### Office Action Summary

10/518,633

ARMER ET AL.

**DETAILED ACTION**

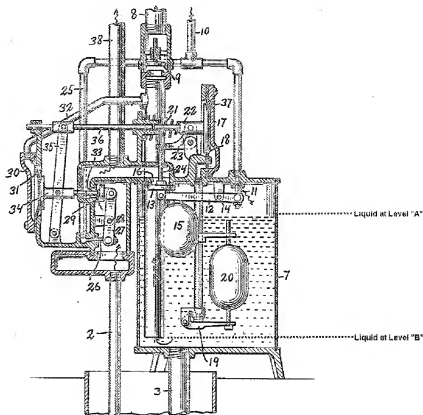
9. In Re claim 1, with reference to blow up of Figure 1 depicted above, Rogers discloses a pump apparatus (title) including:

- a first container including a chamber (4), an inlet (5) and an outlet (6), the chamber being pressurisable (compressed gas entering through tube 2) to effect discharge through the outlet;
- a control apparatus (Fluid motors 17 and 30) for causing periodic pressurisation and depressurisation of the chamber as part of a pressurization/depressurization cycle in response to the level of liquid in the container (once the chamber is full of liquid, the pressurization cycle occurs, therefore it occurs in response to the level of liquid in the chamber),
- wherein the control apparatus includes a pilot valve (11) located in a second

container (7), the second container being connected to, and receiving liquid from, the first container through pipe (3) when the level of liquid in the first container rises to a first predetermined level (which is the level at which the first chamber is full),

- the pilot valve (11) being configured to open when the liquid level in a second chamber (inside 7) is sufficiently high; as evident from Page 2, Lines 25-33: "The drawing shows the parts in the positions which they occupy when the water in the pump chamber 7 is being discharged by the pressure of compressed air .. .. with the compressed air valve open". When the liquid level is at "A" as annotated, the liquid level is "sufficiently high" to push the float (15) against the rocking lever (12) thereby opening valve (11)

- with regard to the claim limitation "to trigger a pressurisation/depressurisation cycle of the chamber of the first container", when the water level in chamber (7) reaches Level "B" as annotated, the system is configured "to trigger a pressurisation cycle" of the chamber of the first container (4). It is noted that there is a time delay between the opening of valve (11) and triggering pressurization of chamber (4) because the pressurization of chamber (4) does not occur until the liquid level has dropped from Level "A" to Level "B", however the examiner points out that the applicant's invention ALSO has a time delay between opening of the pilot valve and pressurization of the first chamber, because the pressure in line 326 of applicant's Figure 3 has to drop sufficiently to overcome the inertia of shuttle valve element 340 so it moves to the right (another time delay occurs to complete the motion of the shuttle valve sufficiently to the right) allowing the compressed air passage to communicate with the first chamber. The

- and to close (valve 11) in response to the liquid level in the second container (7) falling below a second predetermined level "B", which triggers depressurization,

- the state of the pilot valve determining pressure within a portion (16) of the apparatus, and
- a shuttle valve (32, 34, 22, 23, 36) configured to change state directly in response to the pressure within the portion of the apparatus (when the chamber 7 is allowed to exhaust through 16, the rod 26 moves to a position where pressurization of the first chamber 4 occurs),

- the state of the shuttle valve determining whether motive gas enters into, or is vented from, the first container (when the rod 36 of the shuttle valve moves to the left, motive gas enters chamber 4, and when the rod 36 of the shuttle valve moves to the right, motive gas is cut off by 27 and the chamber 4 is allowed to vent) thereby implementing the pressurisation/depressurisation cycle.

11. In Re claim 10, Rogers discloses "high level" annotated as level "A" and a "low level" annotated as level "B". The apparatus being arranged so that when one chamber (4) is discharging fluid, the chamber (7) is receiving fluid (from chamber 4).
